Application for resource consent or fast-track resource consent

The proposal involves the amalgamation of Lot 2 DP 542129 and Lot 1 DP 182616 as well as a s127 change to conditions of 2250266-RMACOM to enable revised subdivision design and staging originally authorised by Resource Consent 2250266-RMACOM.

To:	Far North District Council ("**FNDC**")
Site Address:	39 Aucks Road, Russell / Kororāreka, Far North District
Applicant Name:	Willowridge Developments Limited
Address for Service:	Barker & Associates Ltd PO Box 1986, Shortland Street, Auckland 1140 Attention: Laura Bowman
Legal Description:	Lot 1 DP 542129 Lot 2 DP 542129 Lot 1 DP 187577 Lot 3 DP 420232 Lot 4 DP 420232; and Lot 1 DP 182616. (refer to Records of Title at **Appendix 1**)
Site Area:	43.71 hectares
Site Owner:	Willowridge Developments Limited
District Plan:	Operative Far North District Plan (**ODP**) Proposed Far North District Plan (**PDP**)
Zoning:	**ODP:** Coastal Living & General Coastal Zone **PDP**: Rural Lifestyle & Rural Production Zone
Overlays & Controls:	**ODP:** NRC Flood Susceptible Land **PDP:** Coastal Environment, Coastal Flood Zones 1-3
Designations:	None
Locality Diagram:	Refer to **Figure 1**
B

Figure 6: Revised Scheme Plan

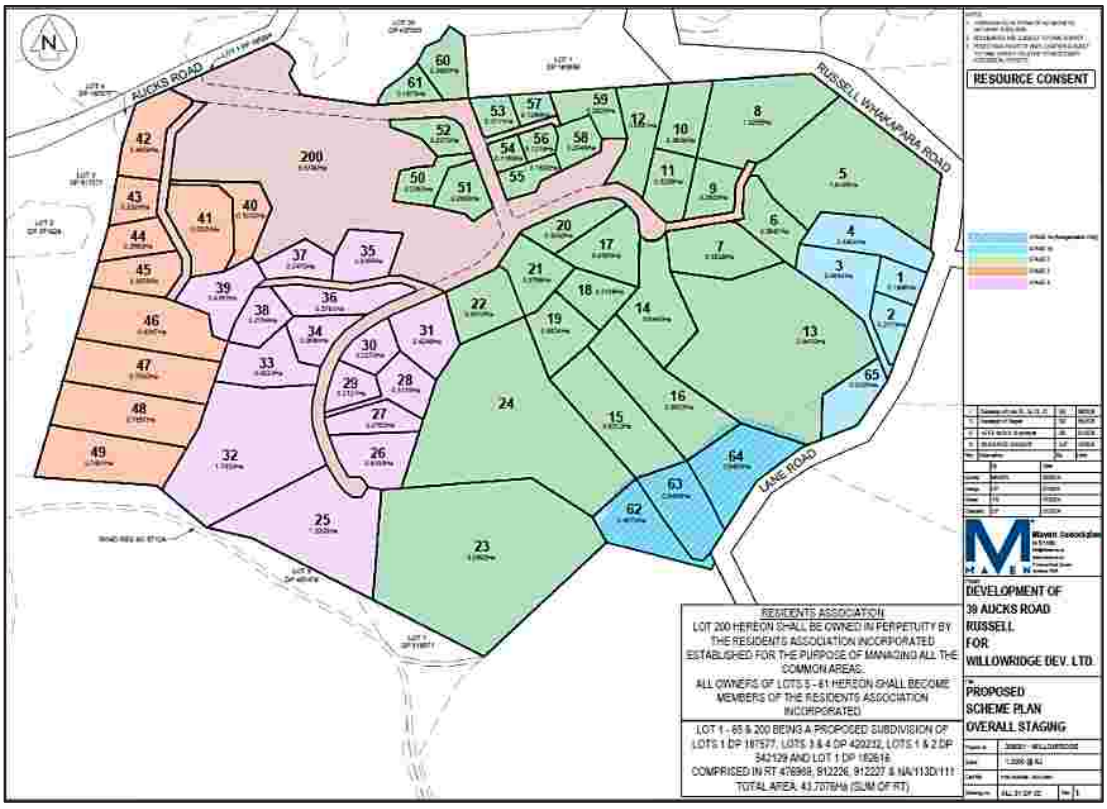
Please refer to the revised scheme plan layout in **Figure 6** below, which has been replicated in full within **Appendix 2** to this AEE.

- Lot 63 will increase from 0.3347ha to 0.5466ha; and
    - Lot 64 will increase from 0.5945ha to 0.6465ha.
- Lot 63 has had a change to the building platform location and size from that approved. Littoralis Landscape Architecture (**LLA**) has provided an updated Landscape Assessment (see **Appendix 6**) in support of this revised location.

- A Right of Way (**ROW**) easement, identified as area 'AA' on the Scheme Plan is proposed to provide access from Lane Road to both Lots 1 and 4;
    - A ROW easement, identified as area 'A' on the Scheme Plan is proposed to provide access from Lane Road to both Lots 2 and 3;

- A ROW easement, identified as area 'B' on the Scheme Plan is proposed to provide access from Lane Road to both Lots 63 and 64; and
    - Lot 62 will obtain access directly from Lane Road via the existing vehicle crossing.

- The bush protection covenant (areas AB & AC) within Lot 4 will be slightly changed due to the revised vehicle access layout and the presence of an existing accessway that is not proposed to be removed or replanted. The covenant area will now be 0.2316ha.

- The revised lot configuration for Stage 2 comprises proposed Lots 5-24, and Lots 50-61. The approved lot configuration for this stage comprised Lots 5-12 and Lots 50-61. This variation therefore seeks approval to amend the subdivision layout by increasing the number of lots within this stage from 20 to 32.

- As a part of the reconfiguration, revised lot areas are also proposed for Lots 13-16, 21, 22, 23 and 24 and are detailed in the updated subdivision scheme at **Appendix 2**.

- Lots 15, 16, 21 & 22 have had a shift in building platform locations from that approved. LLA has provided an updated Landscape Assessment (see **Appendix 6**) in support of these revised locations.

Figure 1: Revised Lots

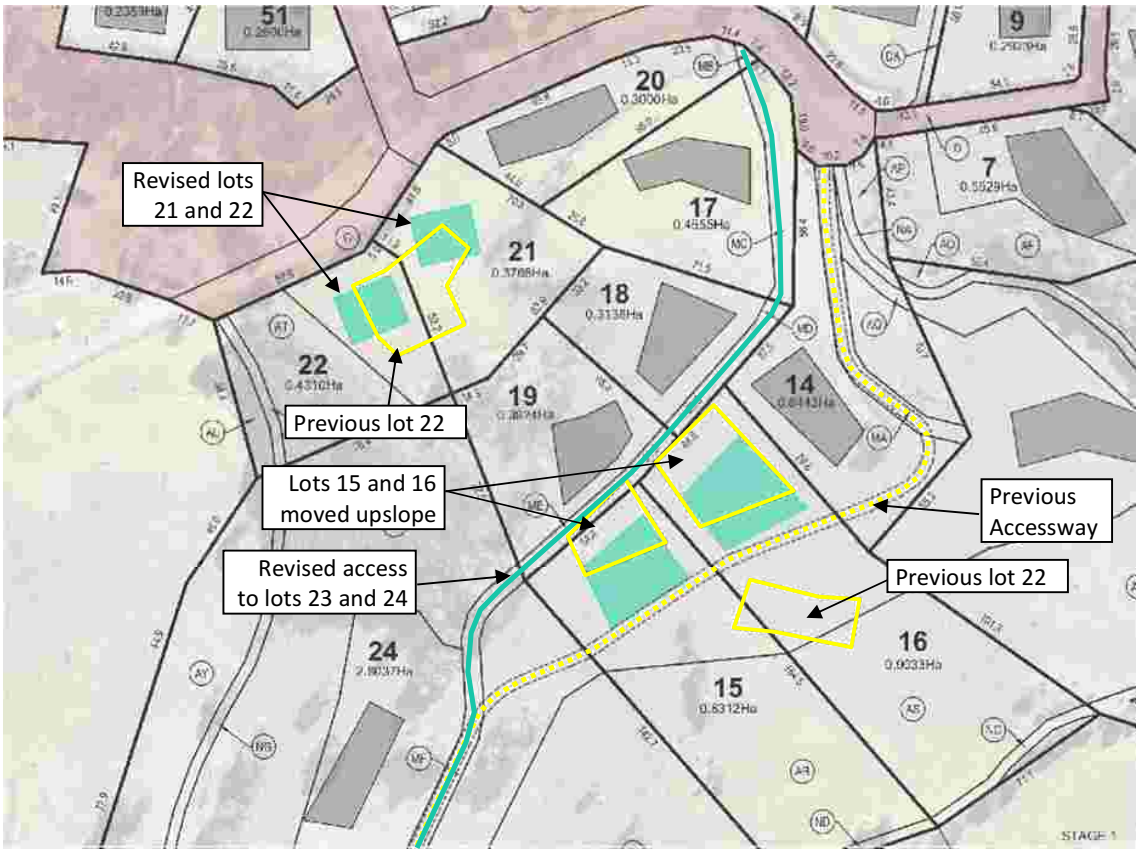
All other lots and building platforms remain as presented in December 2024 geotechnical report. The lots subject to change are illustrated in Figure 1 below.

Figure 1: Proposed Scheme Plan Overview

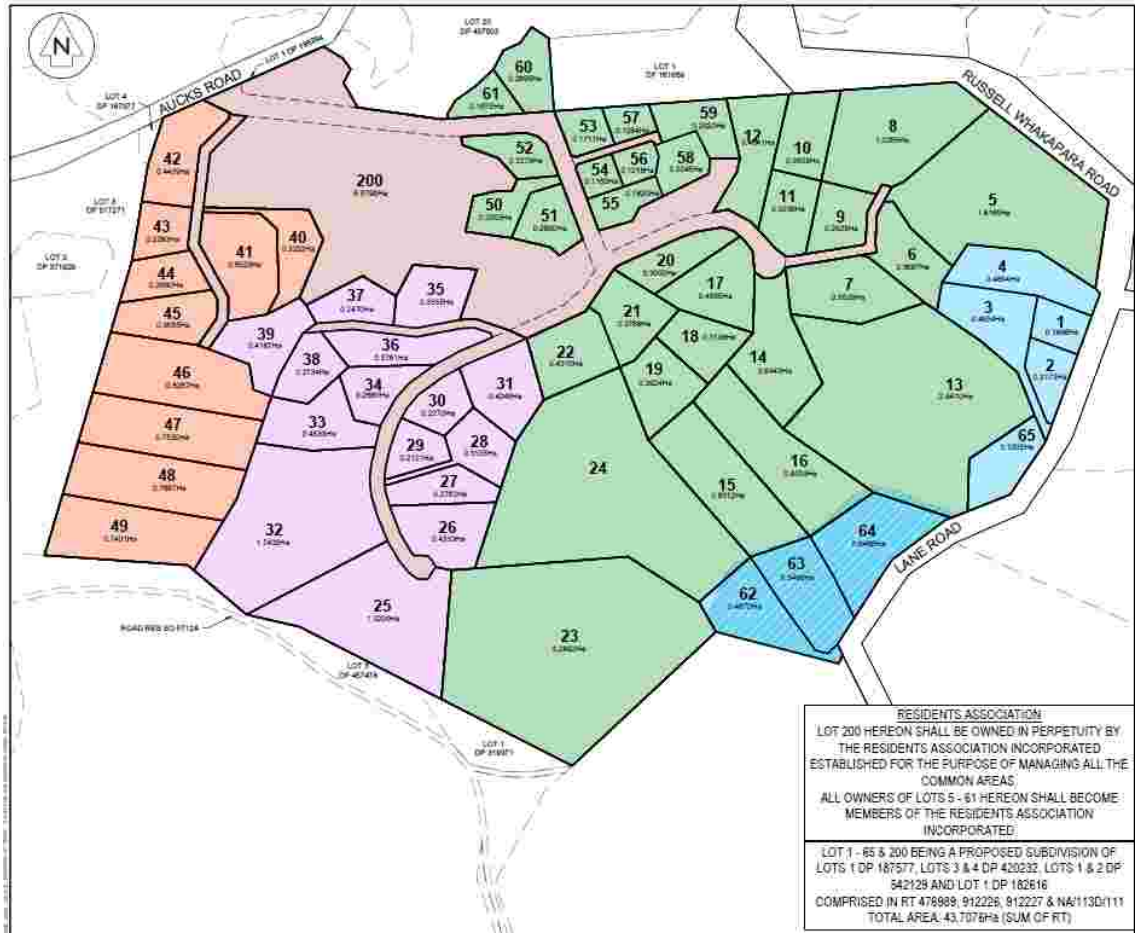
Minor boundary adjustments have been made to the residential lot area because of staging redistribution. These changes are detailed in the accompanying scheme plans and do not impact the overall consented developable area:
